Release Notes – Elmasolvex VA R014

Changes to the Elmasolvex VA software from version R013 to R014

N2

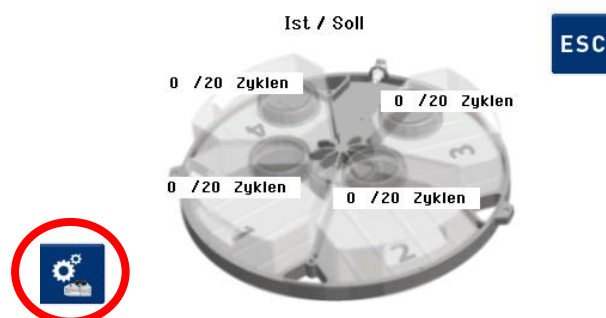
Displaying and resetting the media exchange reminders have been modified. When a counter reaches the set threshold after finishing a cleaning program, this is indicated on the display. Before, this display allowed the user to select whether they want to be reminded again, or whether they want to reset the counters (after query). These options are no longer available in the present display, only the current counter score is shown. Now, in the program selection screen a new icon is shown on the left side which can be used to quickly call up the current counter scores.

If a counter has gone beyond the threshold, the icon shows an additional yellow exclamation mark.

This screen now shows a new icon in the left bottom: the user can use it to call up the settings for the media exchange reminders which allows them to reset the counter quickly, if required.
